Quality Audit

Ardee Main Street, Co Louth

Ardee Regeneration 2040
Louth County Council

Title: **STAGE 2 ROAD SAFETY AUDIT**
For;
Main Street Ardee

Drawing HDC1256 107 Rev 07, South of Dee River bridge.

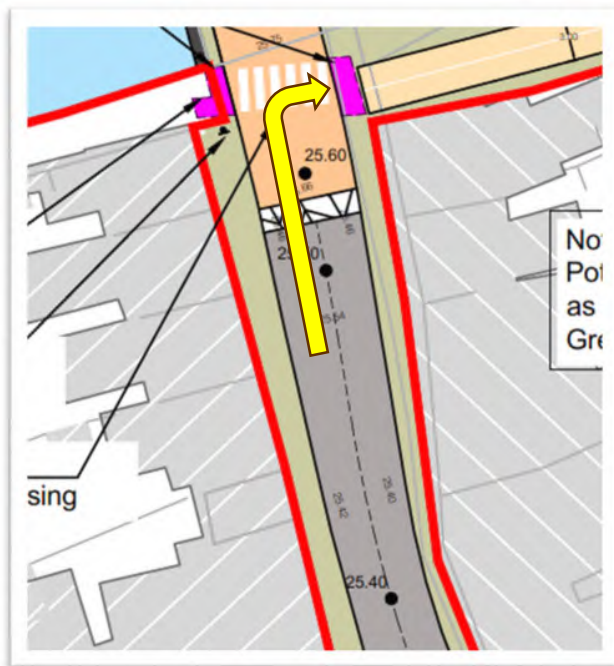
There is no provision for northbound cyclists to exit the N2 and wait to cross the signalised crossing. Cyclists will therefore continue travelling northbound on the Main Street carriageway thereby increasing the risk of collisions with general traffic. A proposal to direct cyclists via Hale Street was suggested in the Feedback Form of the Stage 1&2 Road Safety Audit. That proposal does not appear to be included in this design update.

Drawing HDC1256 107 Rev 07, N52 Barret's Lane.

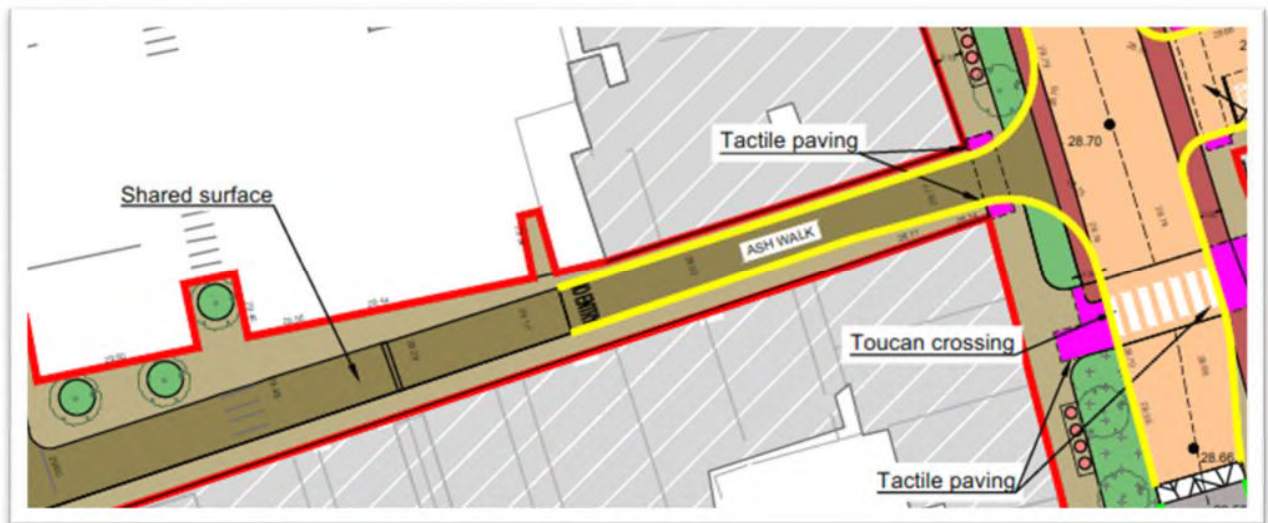
It is recommended that a swept path analysis be carried out for HGVs to ensure that turning manoeuvres can be undertaken. If this cannot be achieved a signalised junction may be required.

Drawing HDC1256 106 Rev 06, Ash Walk, Shared Street.

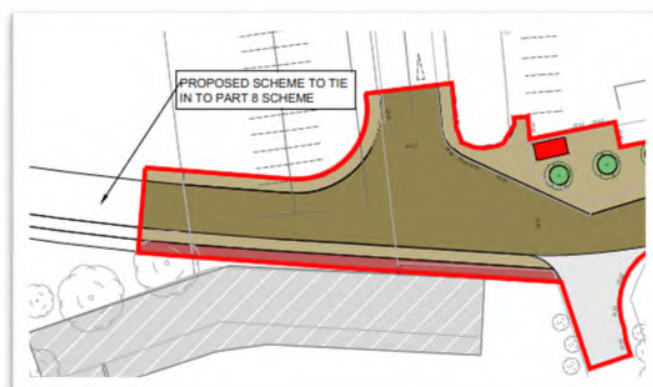
It is recommended suitable details be provided to denote a 'shared street' at its transition from the N2.

Drawing HDC1256 106 Rev 06, Ash Walk.

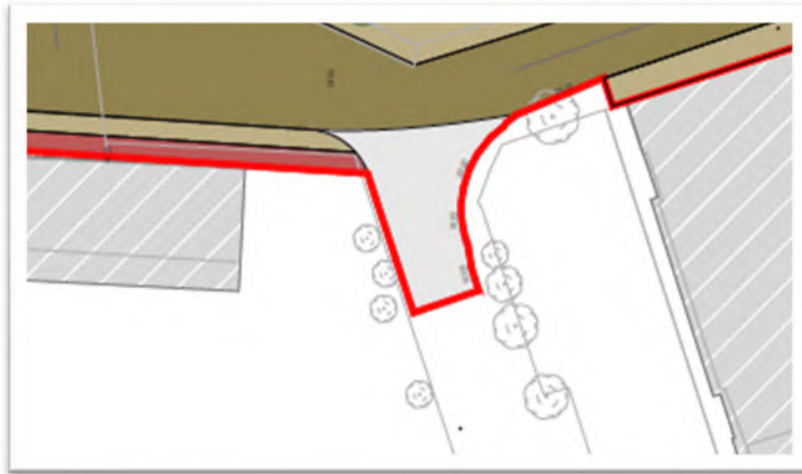
Ash Walk is shown to tie-into a Part 8 scheme at the western end. Ash Walk is shown as a 'Shared Street'. It is unclear if the Part 8 scheme is to be a shared street and if its nature and use will therefore be consistent. A change of street type could increase the risk of collisions with vulnerable road users.

It is recommended that traffic calming be provided along Ash Walk. (It is unclear if an existing raised table is to be retained)

Drawing HDC1256 106 Rev 06, Ash Walk, tie in with link road to the N52.

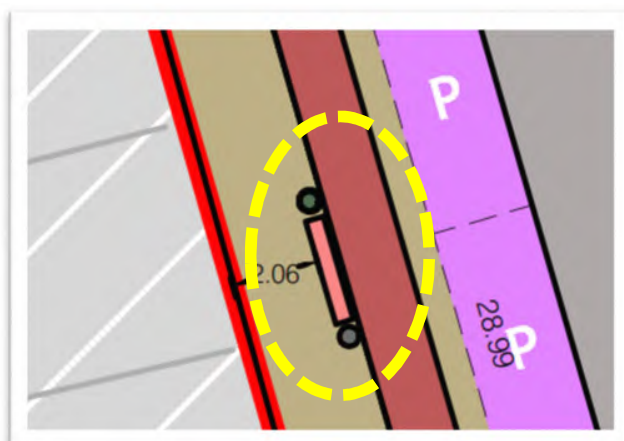
The link road to the N52 from Ash Walk is not shown to be a shared street. A change of street type could increase the risk of collisions with vulnerable road users.

It is recommended that that consistency in street type be provided or that a suitable transition be provided.

Drawing HDC1256 106 Rev 06, benches adjacent to the cycle lane.

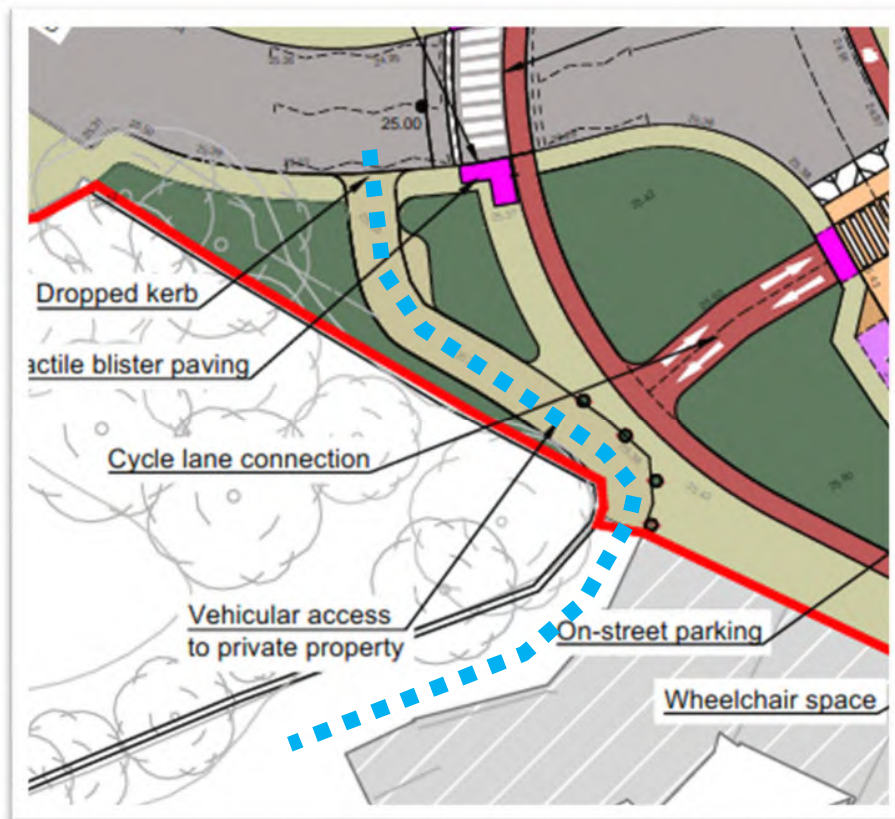
It is proposed to provide benches adjacent to the cycle track. If they are located too close to the cycle track they may be hazards for cyclists who may get their handlebars caught leading to loss of control and falls.

It is recommended adequate offset be provided at the edges of the cycle track without obstacles.

Drawing HDC1256 1002 (K) Rev 03 Kerb Layout, Access to private garage off N2.

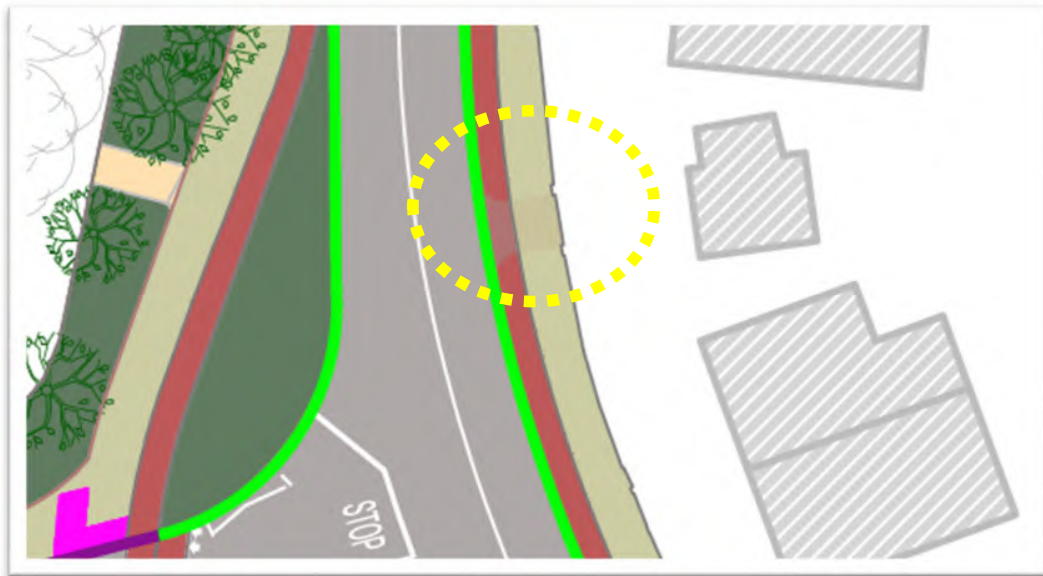
The drawing shows a 125mm high kerb at the proposed vehicular access to the private garage on the eastern side of the N2 just north of the Golf Links Road junction. A high kerb could lead to vehicles 'bouncing back' when trying to access the driveway to the garage resulting in rear-end collisions.

It is recommended that the kerb height be adjusted to facilitate vehicular access.

Drawing HDC1256 1002 (K) Rev 03 Kerb Layout, Relocated Bus stop and bus shelter, south bound.

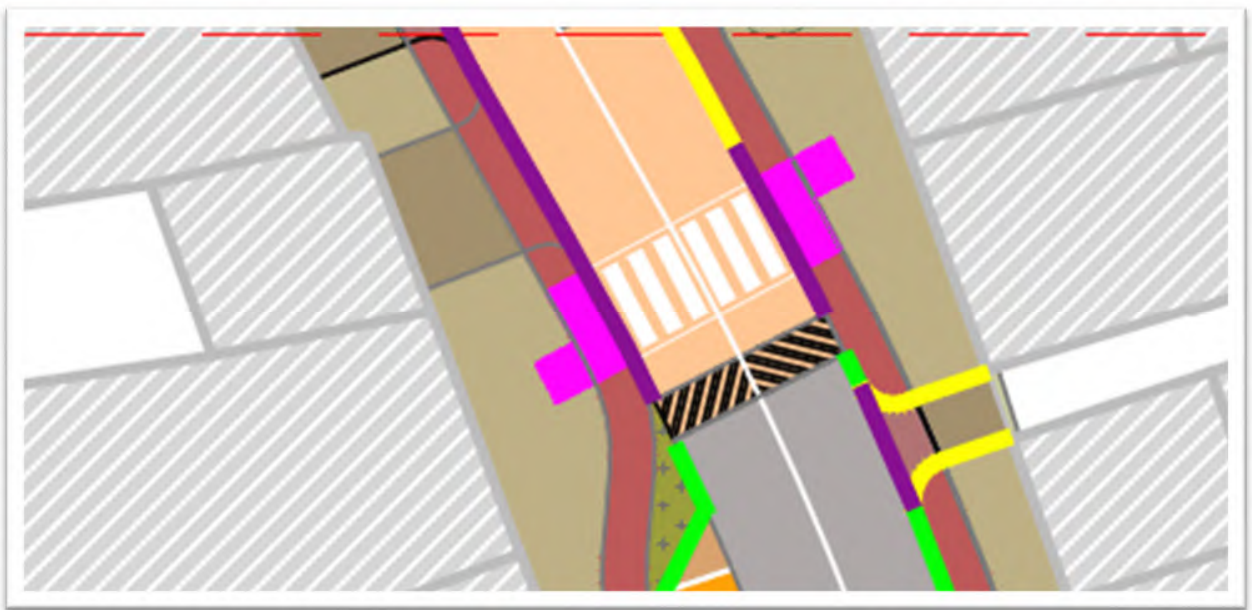
It is recommended that the layout be changed to provide adequate space for bus users without conflict with cyclists.

Drawing HDC1256 1002 (K) Rev 03 Kerb Layout, Zebra Crossing.

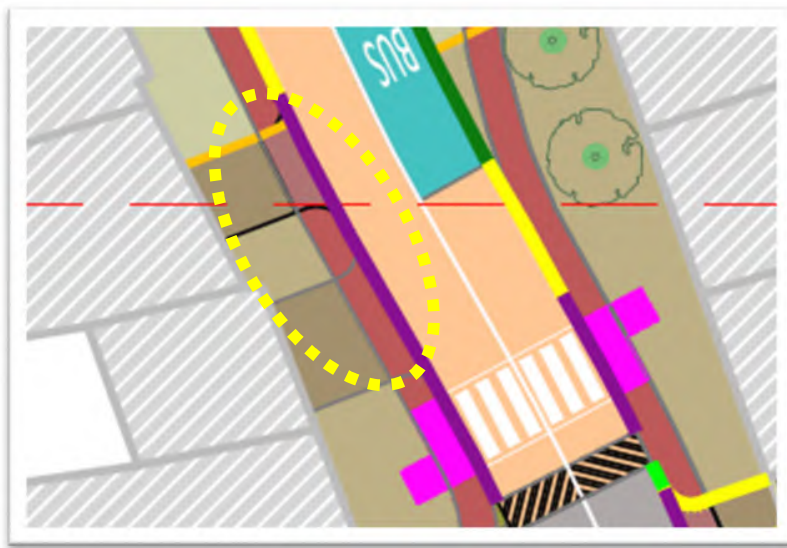
It is recommended that a shared use area be developed at both sides of this zebra crossing and other similar crossings.

Drawing HDC1256 1002 (K) Rev 03 Kerb Layout, Flush Kerbing.

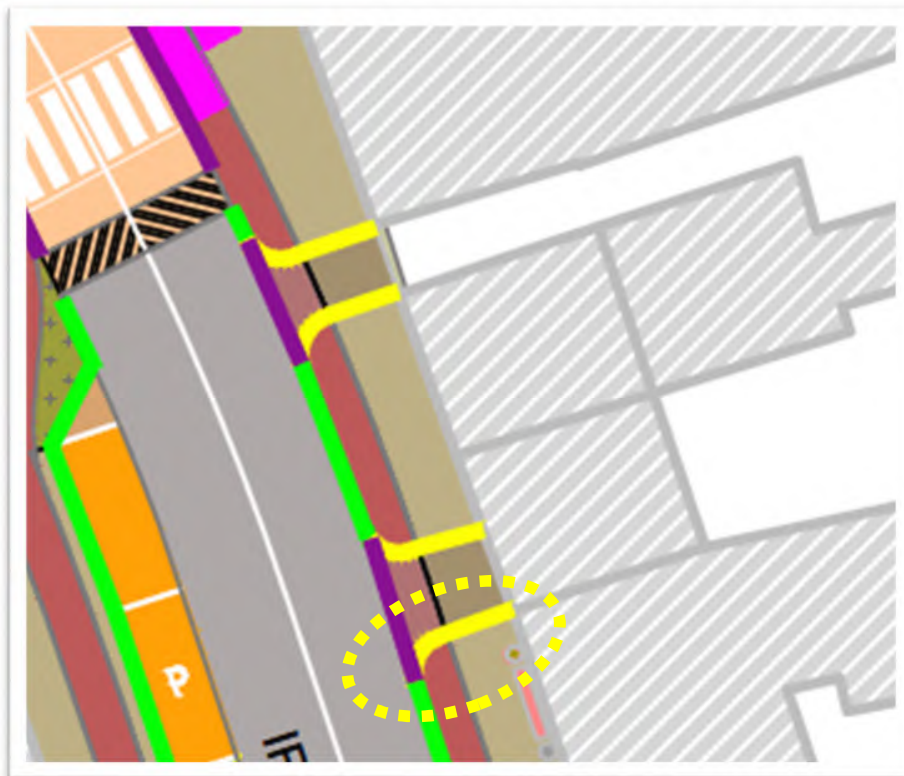
It is recommended that flush kerbs only be provided at crossing points or access areas for pedestrians only.

Drawing HDC1256 1002 (K) Rev 03 Kerb Layout, 50mm high kerbing at accesses.

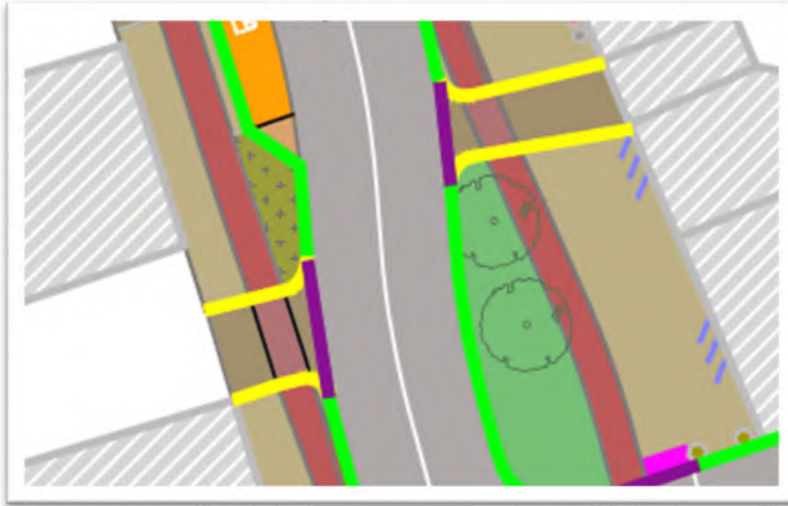
It is proposed to provide 50mm high kerbing at some accesses across the footpath. This would be a trip hazard and would lead to inaccessibility for mobility impaired pedestrians.

It is recommended that flush kerbs be used or no kerbs and that continuous footpath and cycle track facilities be used.
